**HISTORIC PRESERVATION REVIEW BOARD
STAFF REPORT AND RECOMMENDATION**

Landmark/District:	Georgetown Historic District	(x) Agenda
Address:	1728 Wisconsin Avenue NW	
Meeting Date:	October 5, 2017	(x) Addition
Case Number:	17-446	(x) Demolition
Staff Reviewer:	Tim Dennée	(x) Permit

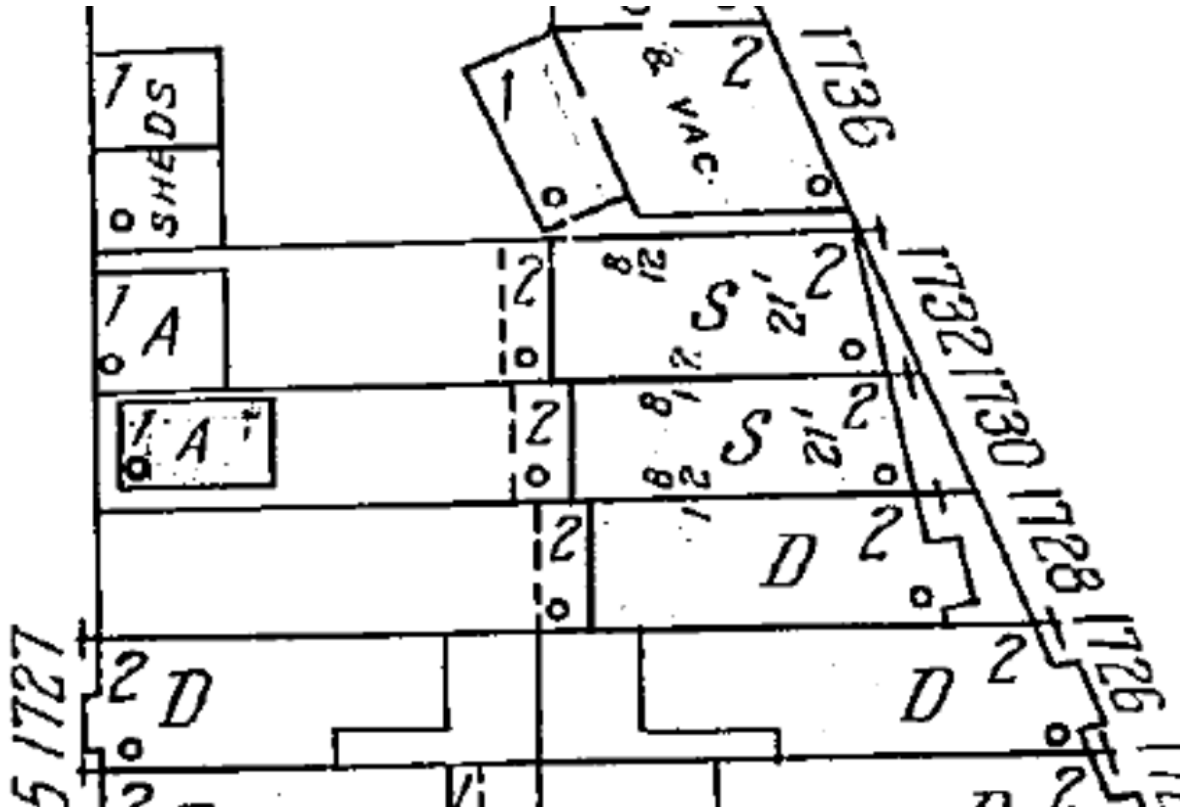
Section 305.3 of the historic preservation regulations state that “[t]he filing of an application for a demolition permit shall be considered to incorporate a request for determination whether the property contributes to the character of a historic landmark or district pursuant to § 704 of this title.” We do not have an application expressly for demolition; the demolition is depicted incidentally in an application that is characterized as “Interior remodeling with an addition to the rear and a third story addition.” But the demolition of exterior walls and roof makes unclear what would then constitute the interior, and the rear addition takes the place of an older one, which is to be lost. One may be skeptical of the demolition-section drawings on sheet A011, at least for the reason that the existing roof is not flat, as shown, but slopes rearward, meaning that it cannot serve as the third floor without significant modification. It remains to be seen whether other floor framing indicated for retention will actually be retained.

HPO has requested that the architect take a hard look at retaining more of the structural elements and exterior walls. It should be noted, for instance, that the original rear wall (the rear of the main block) is to be demolished, only to have a new wall constructed in its place. Even piers which help support the façade are to be removed.
